May 01, 2006  
FINAL SUBMITTAL

## ADA COMPLIANCE STUDY

Submitted By:  
Heery International, Inc.  
999 Peachtree Street, N.E.  
Atlanta, Georgia 30309-3953  
404-881-9880

*Drinking Fountain 1*

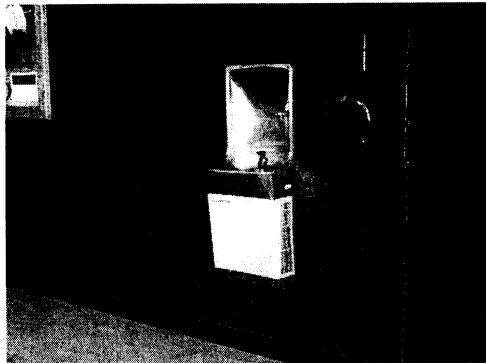
Non-compliant knee space clearance, height of spout & twist faucet handle

*Drinking Fountain 2*

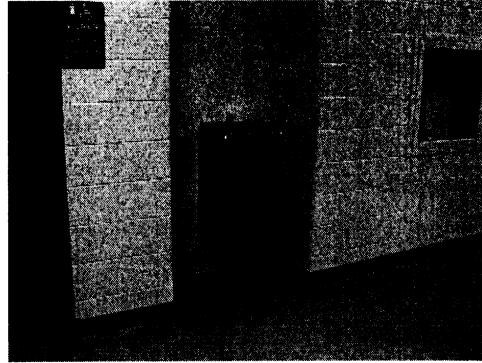
Non-compliant knee space clearance, height of spout & twist faucet handle

*Public Telephones*

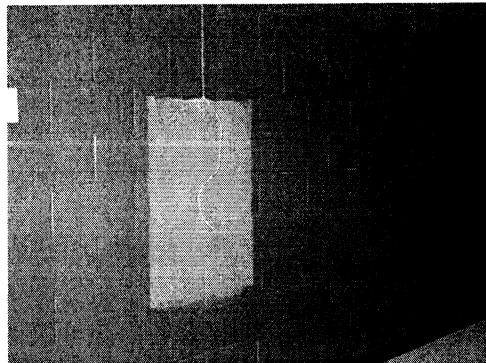
Removed leaving no compliant telephones in the building

*Interior Handrail 1*

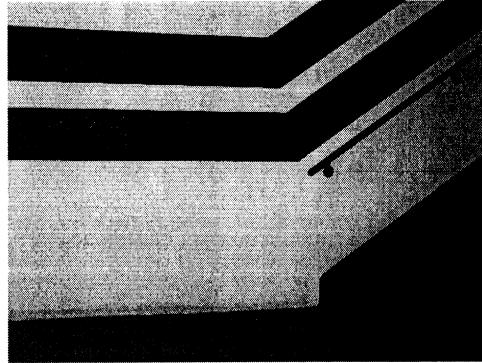
Missing 12" horizontal extension to handrail

*Interior Handrail 1*

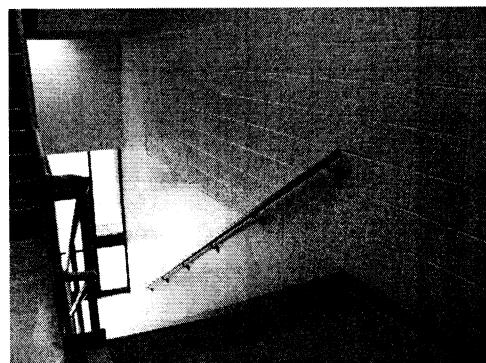
Missing 12" horizontal extension to handrail at top and bottom landings

*Lavatories & Accessories 1*

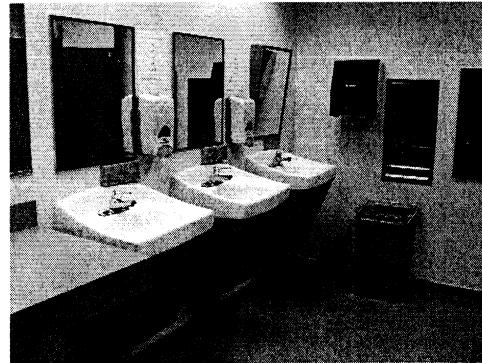
Non-compliant insulation wrap at lavatory piping, faucet handles, height of paper towel dispenser and height of lavatory

*Lavatory Insulation*

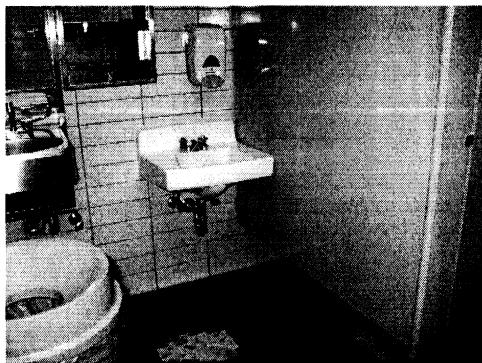
Non-compliant lavatory insulation wrap on piping, faucet handles and lavatory side clearances

*Lavatories & Accessories 3*

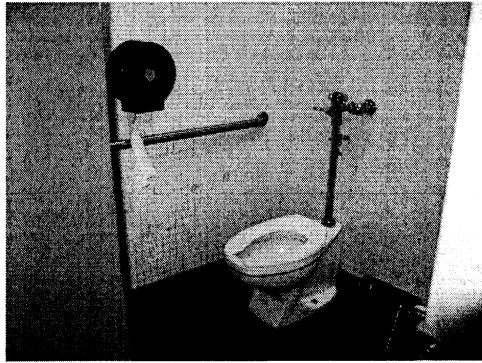
Non-compliant height of lavatory, height of towel dispenser and lavatory side clearance

*Toilet Location and Grab Bars*

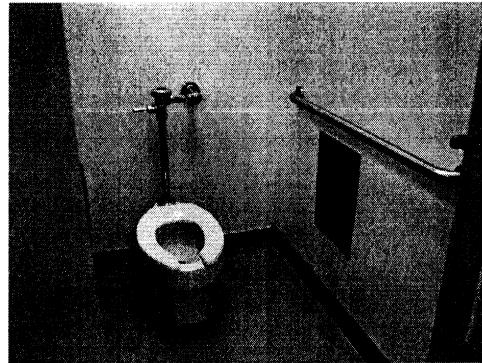
Toilet too far from wall and missing back grab bar

*Dispenser Type & Location*

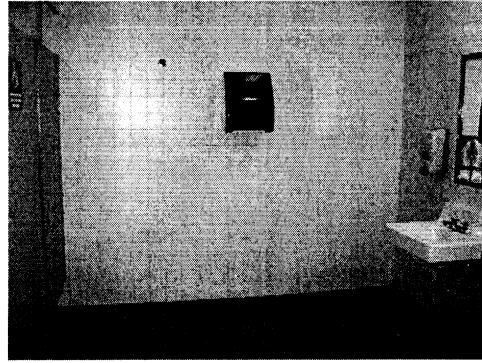
Non-compliant dispenser type (two hands required) and mounted too high
